PROPOSED CHANGES FROM PREVIOUS APPROVAL.

SECTION A PROPOSED SHEET NO. **130** REVISION. **D**

33 FITZROY SQUARE LONDON W1T 6EU JOB NO. **262**

1:50 @ A1, 1:100 @ A3
 PROPOSED SECTION A

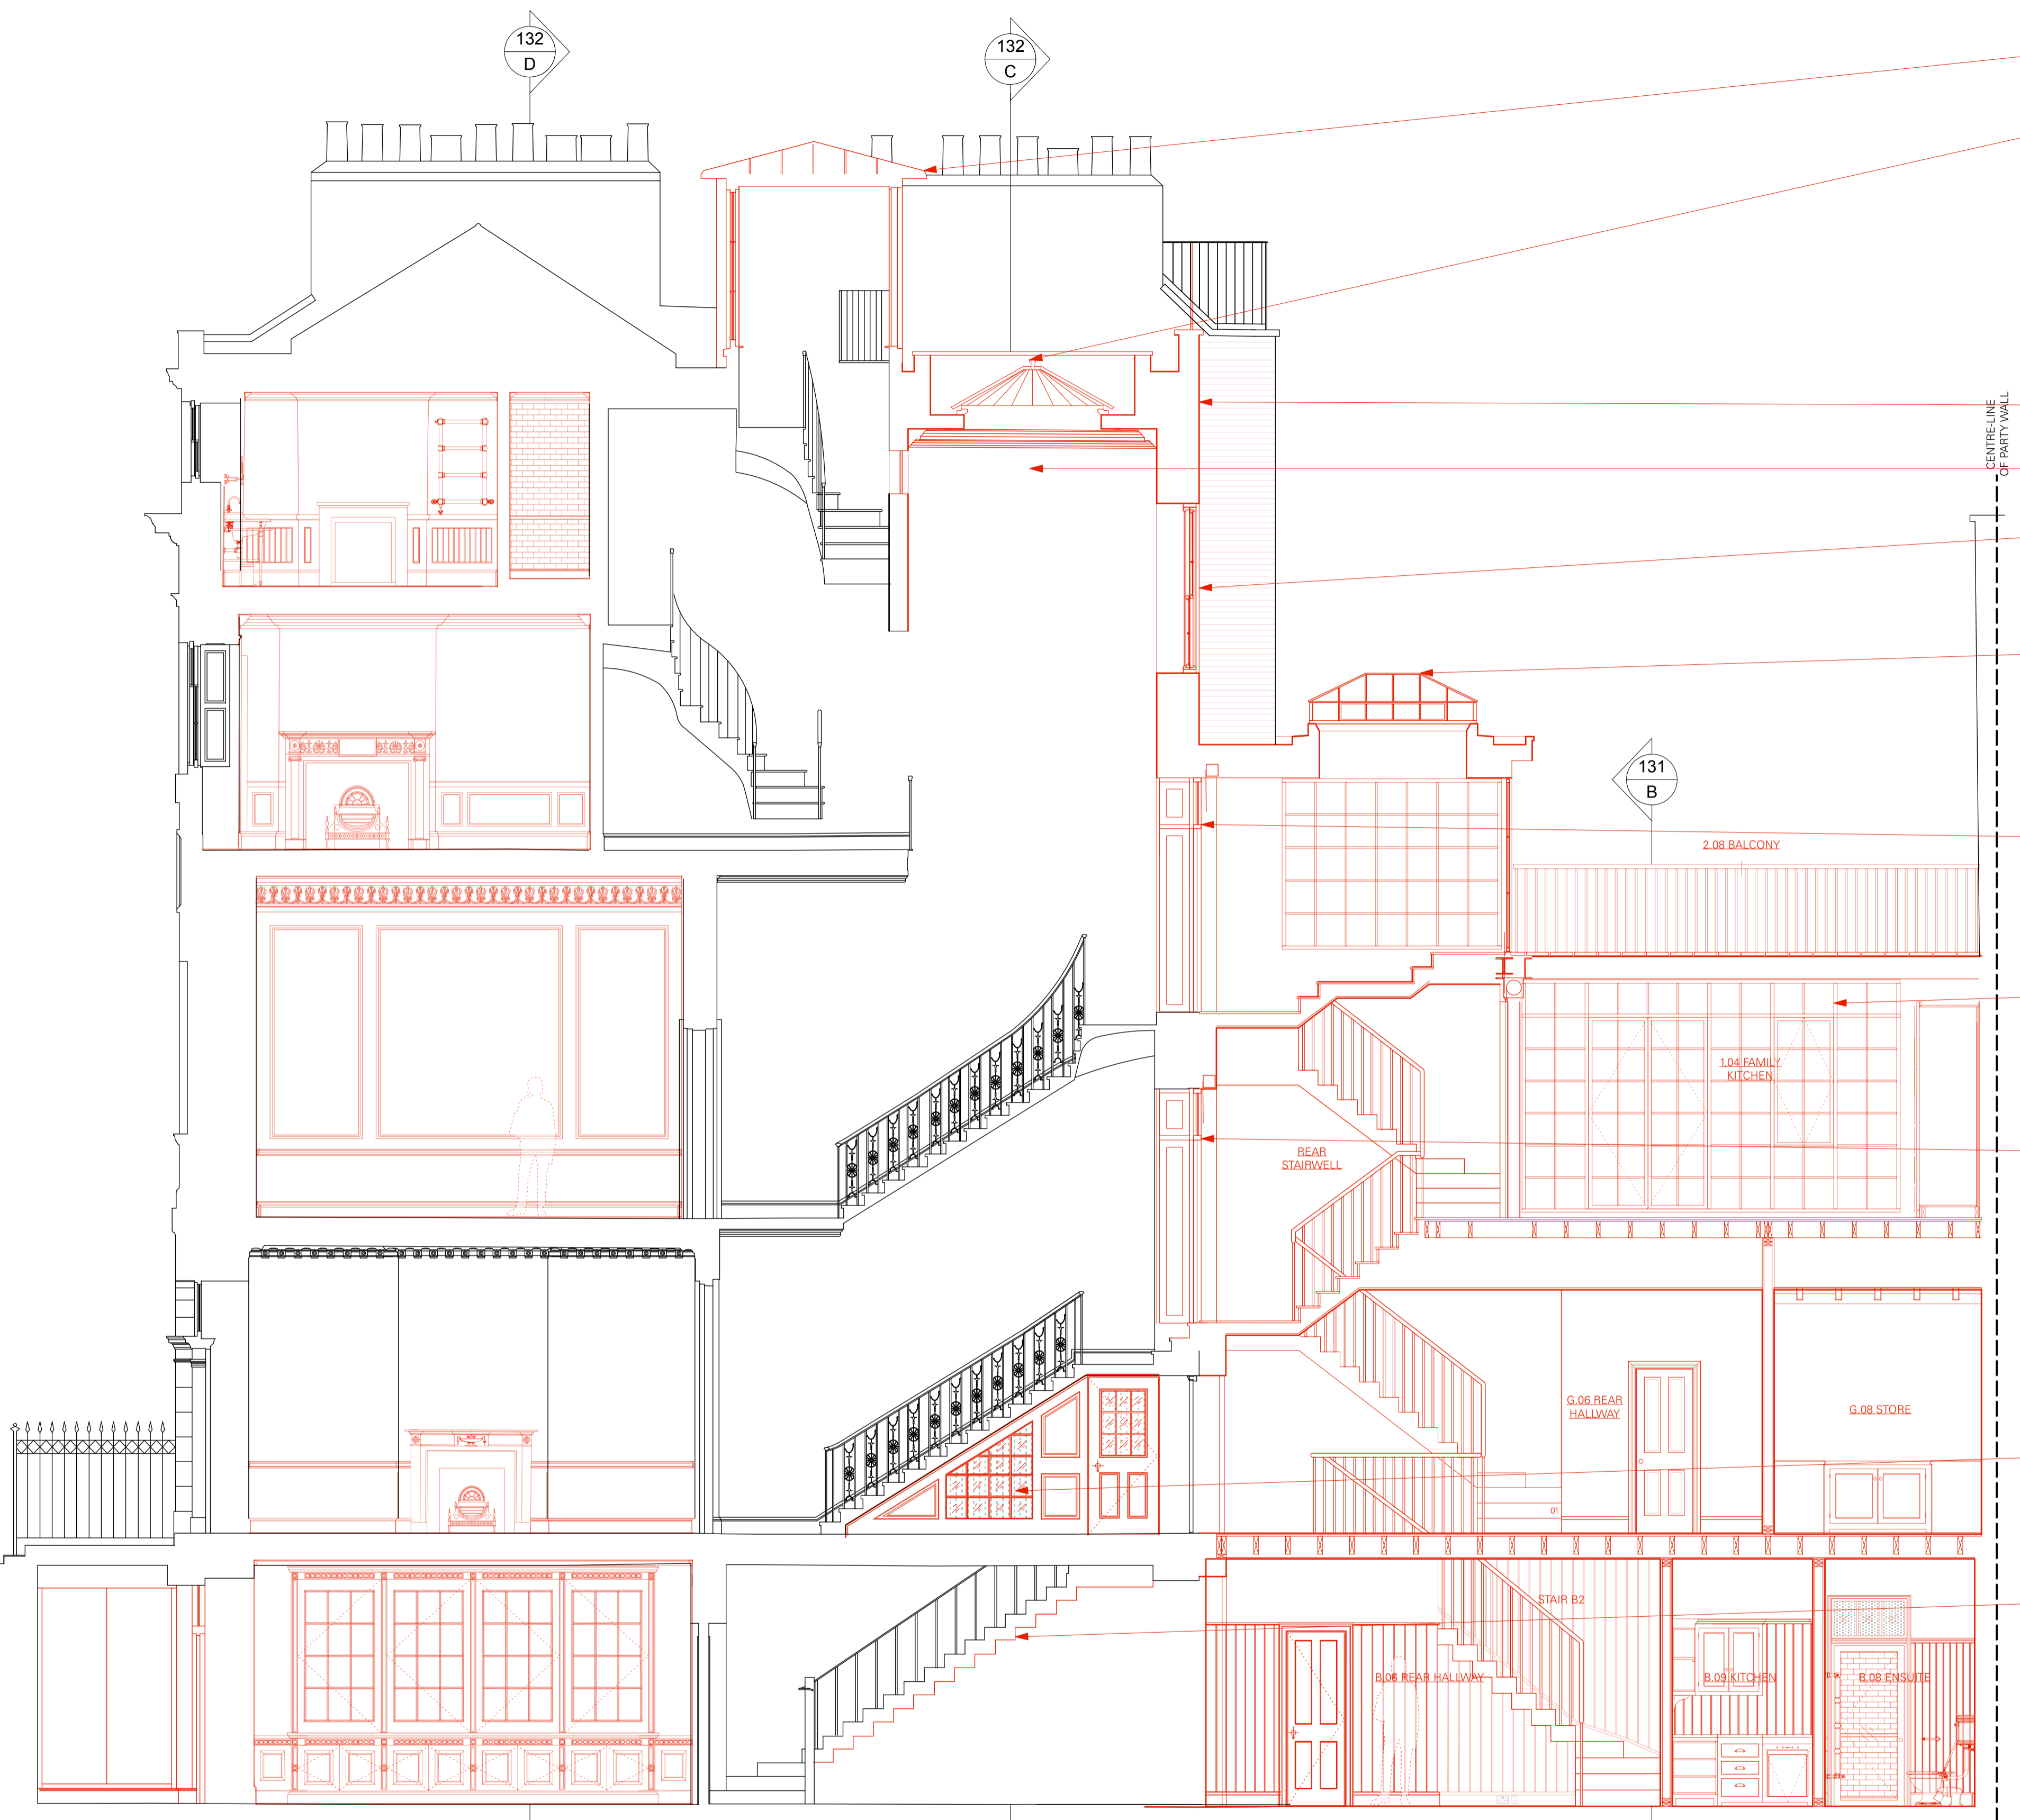
REPLACE TIMBER, GLASS & LEAD BELVEDERE WITH STEEL AND GLASS BELVEDERE TO MATCH OTHER ADDITIONAL FENESTRATION.
 NEW WALK-ON GLASS TERRACE TO REPLACE TIMBER BOARDED TERRACE TO ENABLE LIGHT TO NEW OCULUS ROOFLIGHT BELOW.

STAIRWELL WALL TAKEN BACK TO ORIGINAL BUILDING LINE.

REMOVAL OF KITCHEN AT THIRD FLOOR AND OPENING UP OF STAIRWELL TO DOUBLE HEIGHT WITH OCULUS ROOFLIGHT ABOVE.

AMENDED SIZE AND POSITION OF NON-ORIGINAL WINDOW

ROOFLIGHT AMENDED TO BE MORE IN KEEPING WITH TRADITIONAL STYLE AND WINDOW FENESTRATION.

NEW DOOR TO APPEAR AS ADAPTED WINDOW.

WINDOWS AMENDED TO MORE TRADITIONAL STYLE AND WINDOW FENESTRATION.

NEW DOOR TO APPEAR AS ADAPTED WINDOW.

AMEND STAIRWELL JOINERY

REMOVE NON-ORIGINAL JOINERY BENEATH STAIR AND EXPOSE STAIRWELL AS WOULD HAVE BEEN ORIGINALLY.
